Appln No. 09/826,435

Reply to Office action of November 3, 2004

REMARKS/ARGUMENTS

FIG. 1a
 (PRIOR ART)

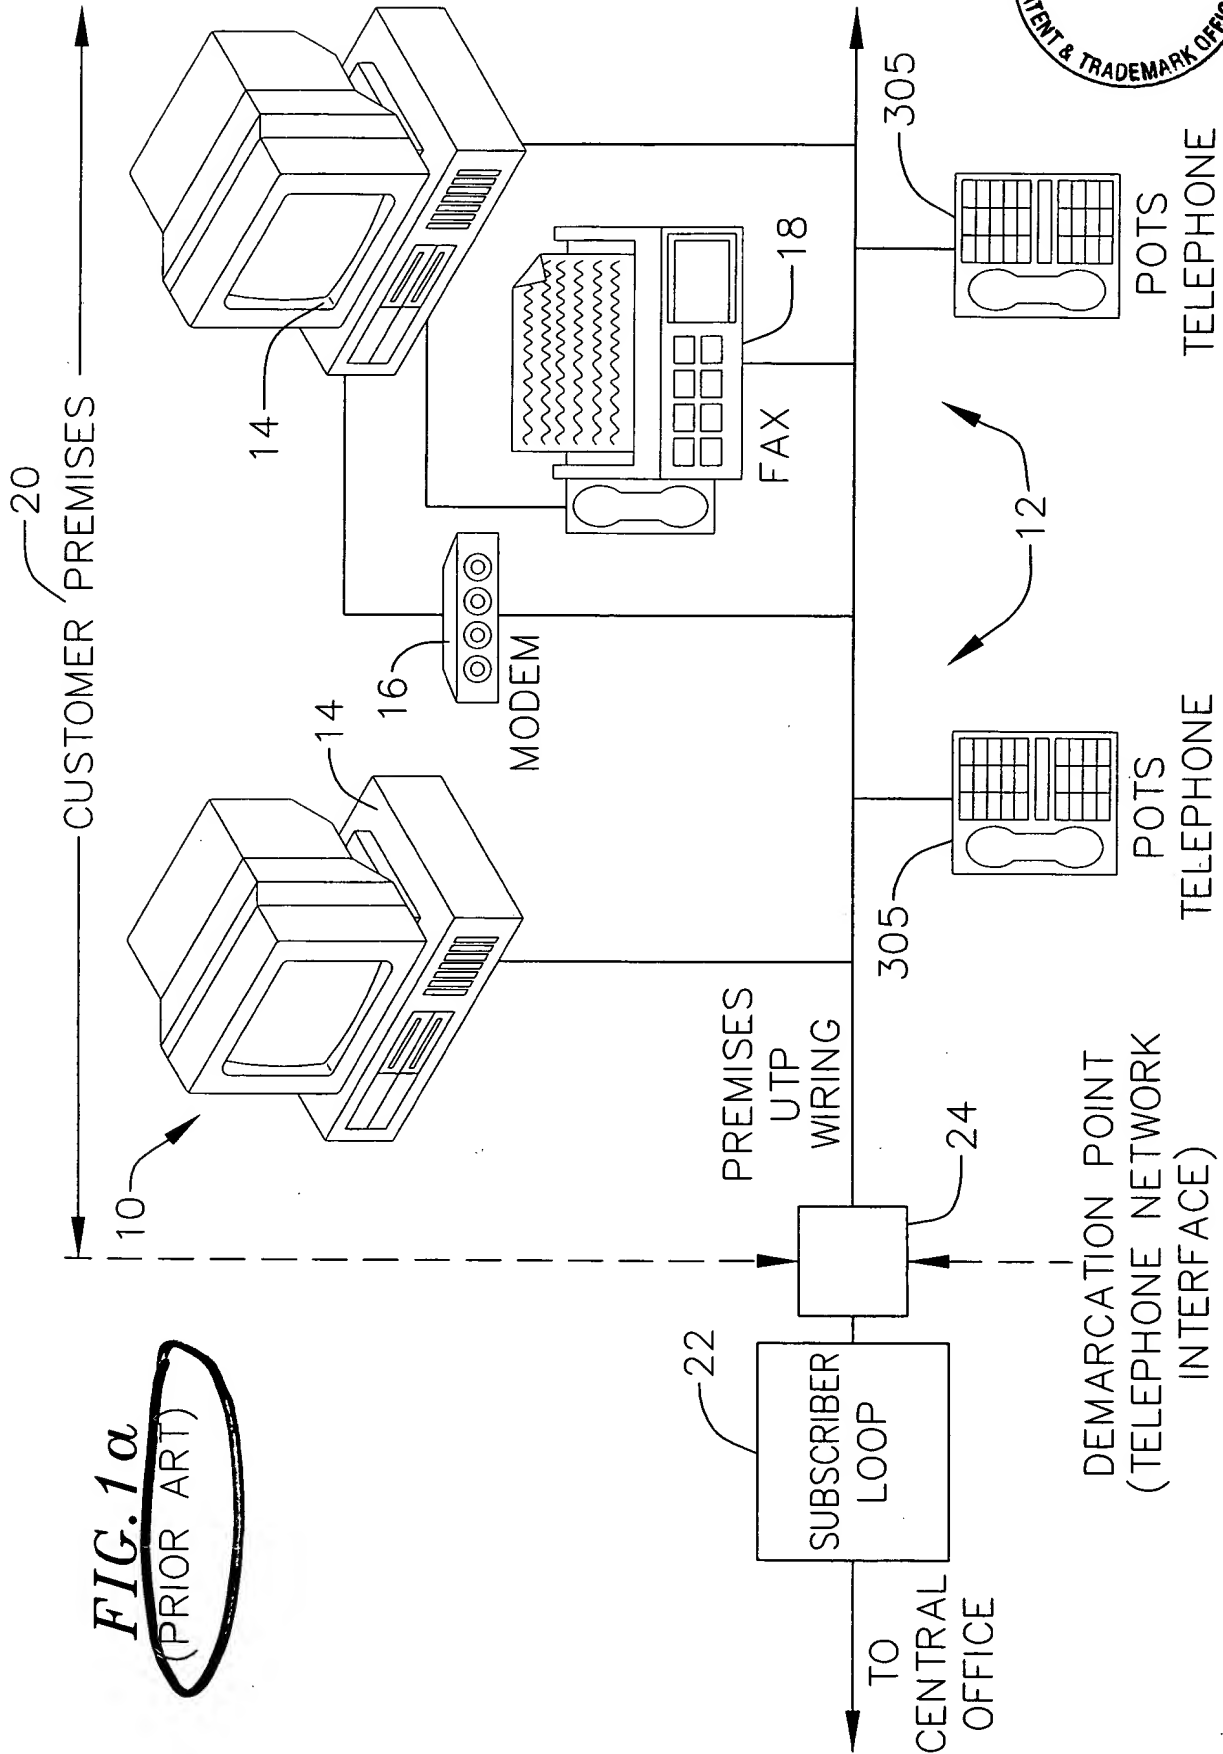
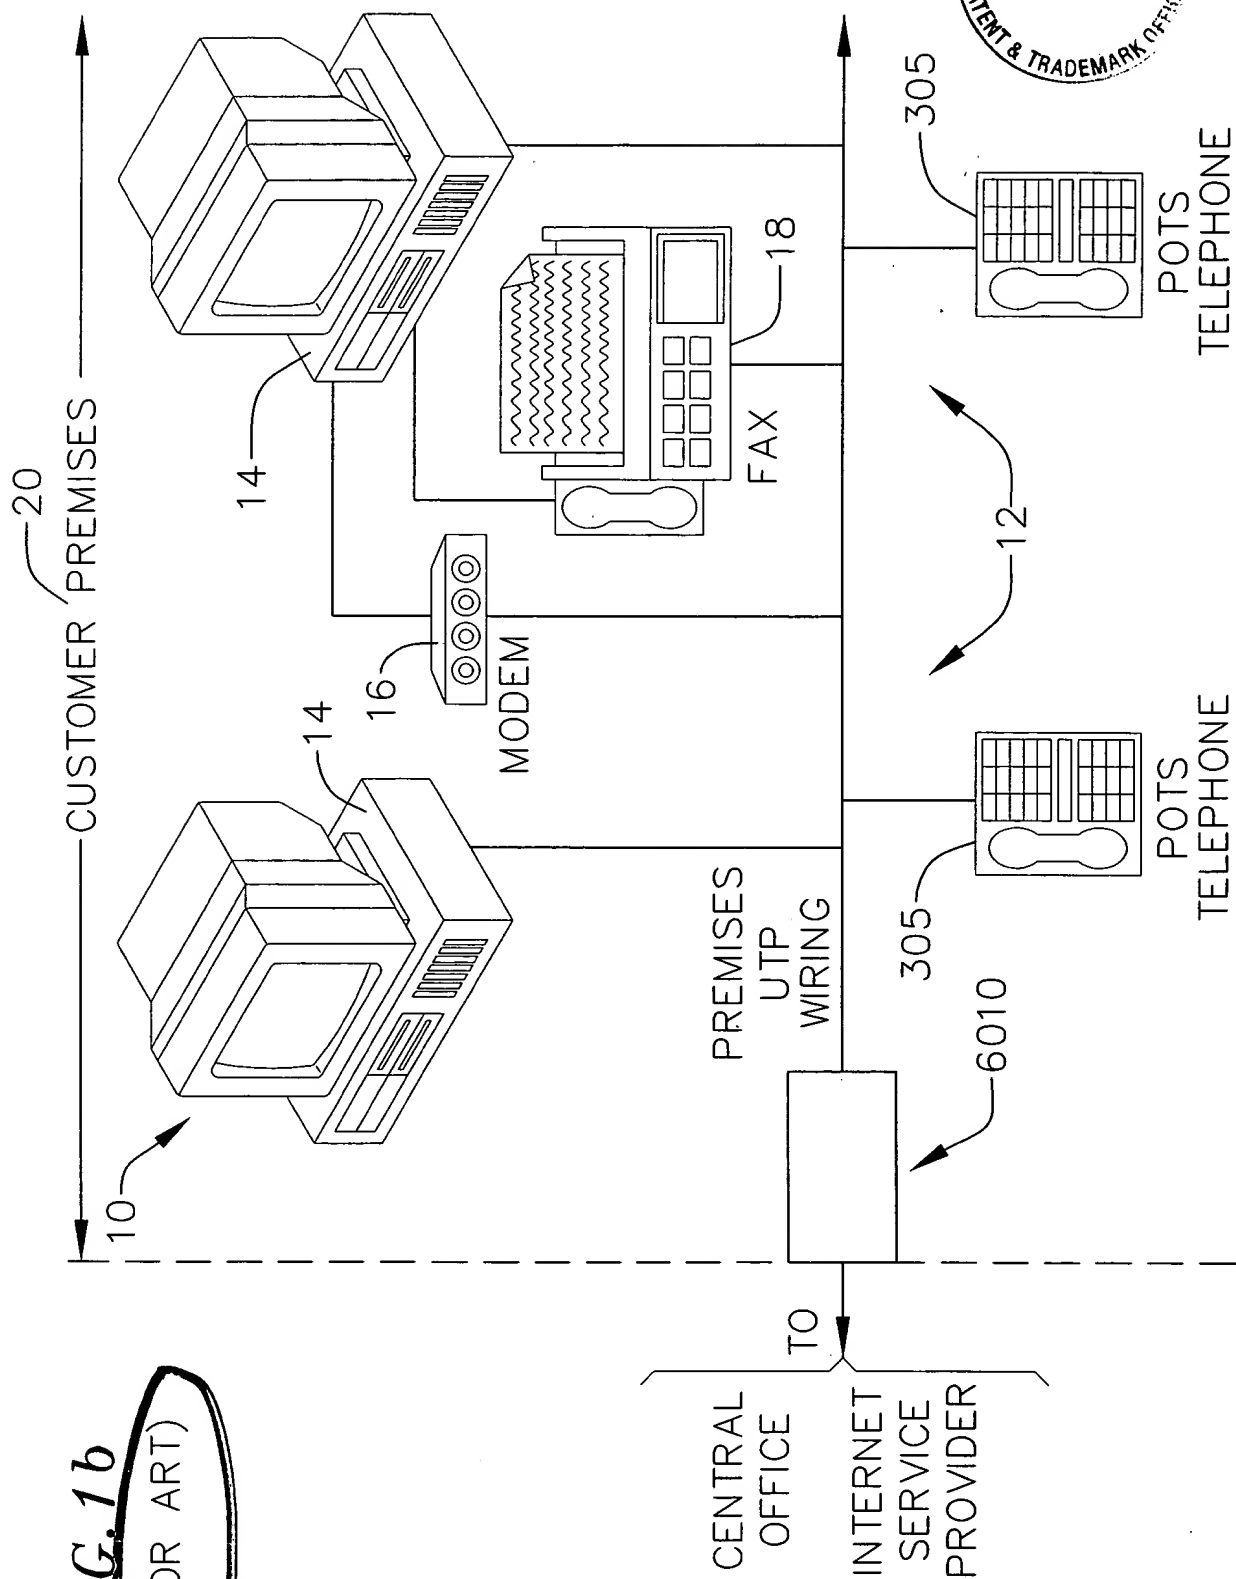
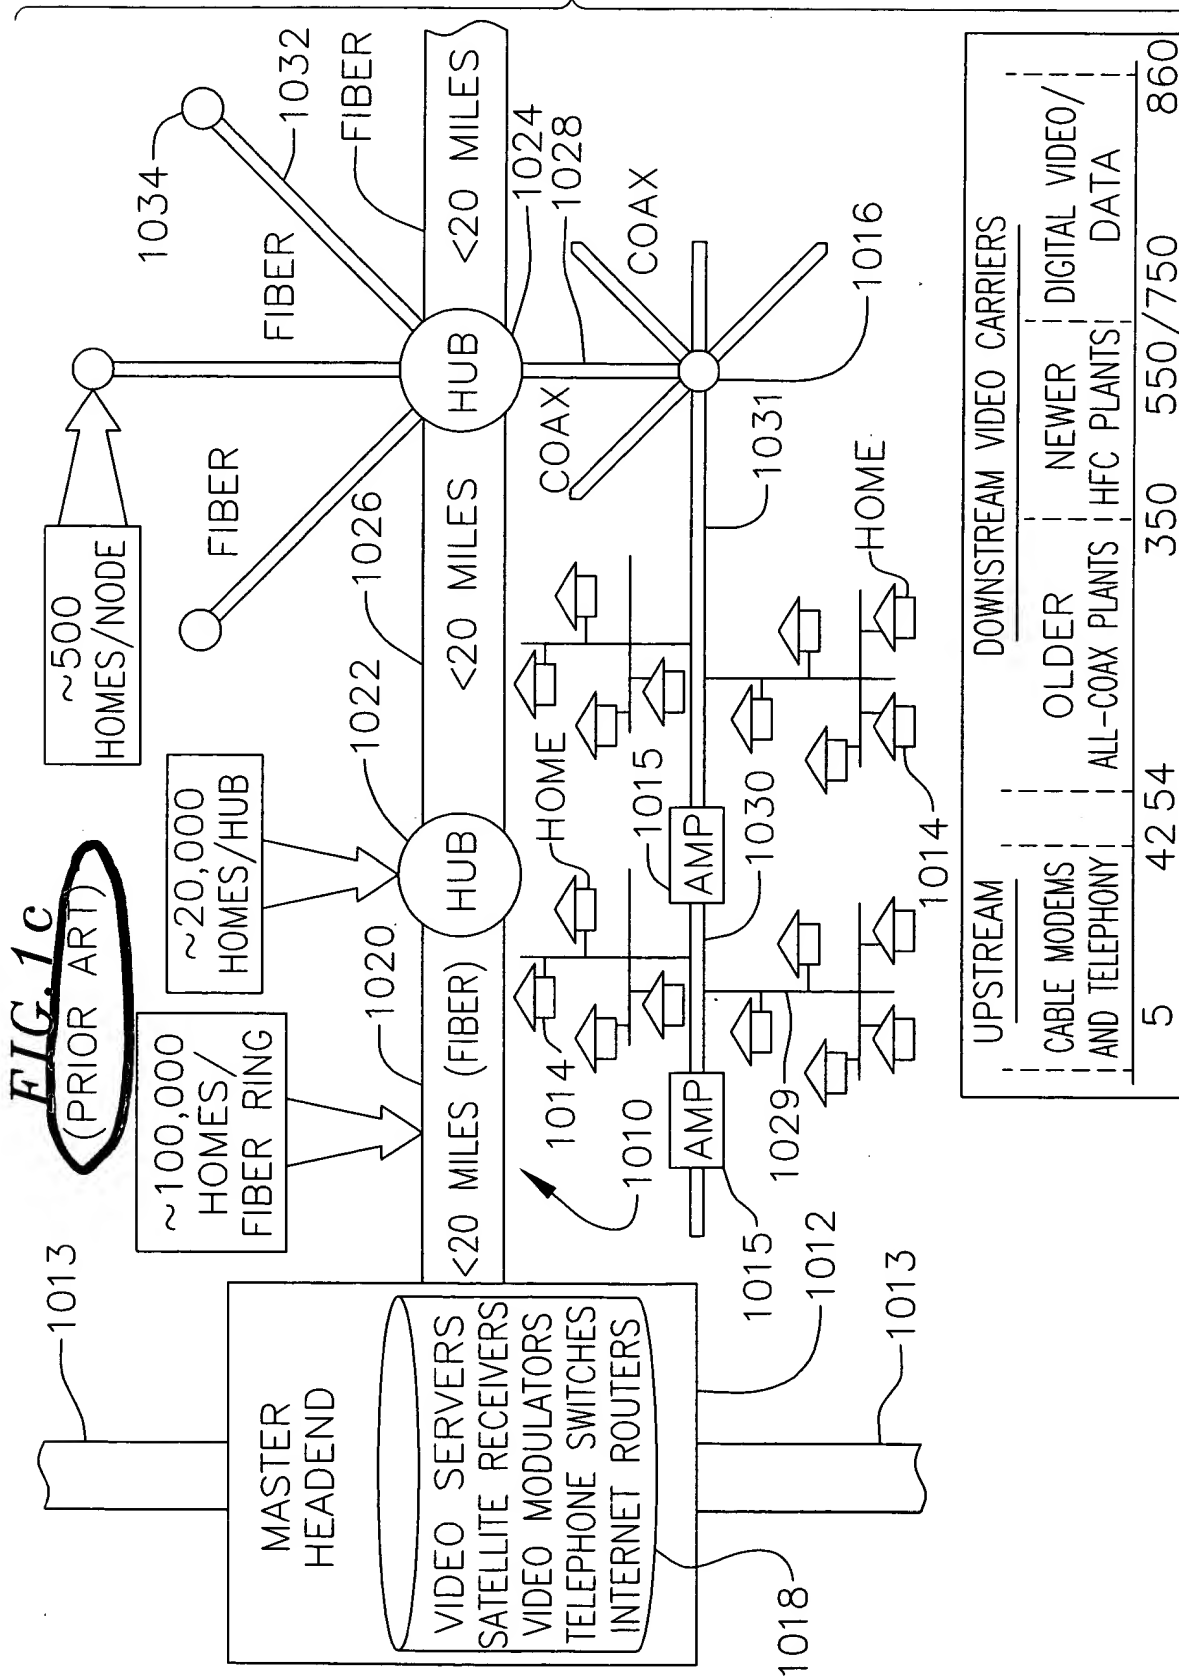
The Examiner has objected to the Drawings indicating that Figs. 1a - 1d should be labeled as prior art.

The Applicants have amended Figs. 1a - 1d accordingly.

replacement sheets of amended Figs 1(a) - 1(d), along with
annotated versions thereof, and
